UNITED STATES PATENT AND TRADEMARK OFFICE

APPLICATION NO.	FILING DATE	FIRST NAMED INVENTOR	ATTORNEY DOCKET NO.	CONFIRMATION NO.
09/476,521	01/03/2000	Herbert Gropp	RUM212	7964

Office Action Summary

Fig. 1

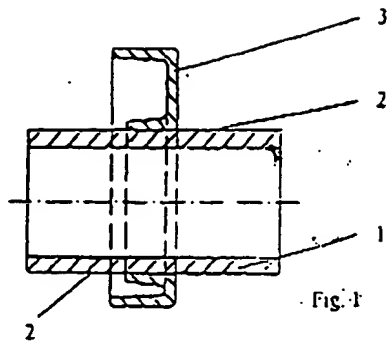
The original drawings show only two coatings, *i.e.*, the first and second coatings 2 and 5, the pipe 1 and the cams 3. See page 6 of the original specification and original claims 1-5.

First, lines 17-20 of claim 9 claim a *third* compression joint, and a *third* crystalline phosphate coating. Similarly, lines 12-16 of claim 10 claim a third longitudinal compression joint and a third joint-stable surface coating. However, the original drawings (Figs. 1-3) show

Fig. 3

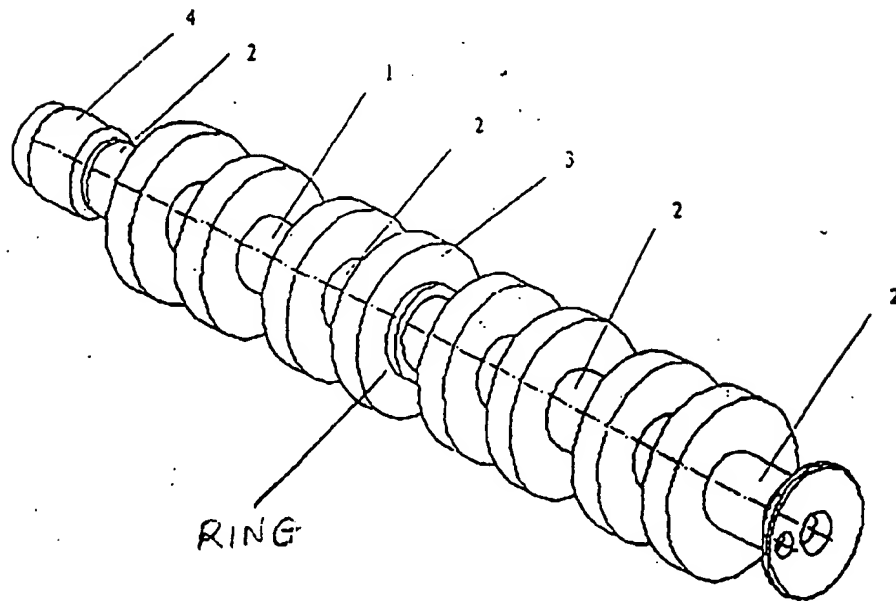
(b) New Fig. 3 introduces new matter, such as, the deletion of a ring (unnumbered, see Attachment attached). The original Fig. 3 shows the ring located adjacent to the cam 3, however, new Fig. 3 now does not show such ring. See *Twin Disc v. United States*, 231 USPQ 417, 435 (US Cls. Ct. 1986)(new matter by deletion).

RING
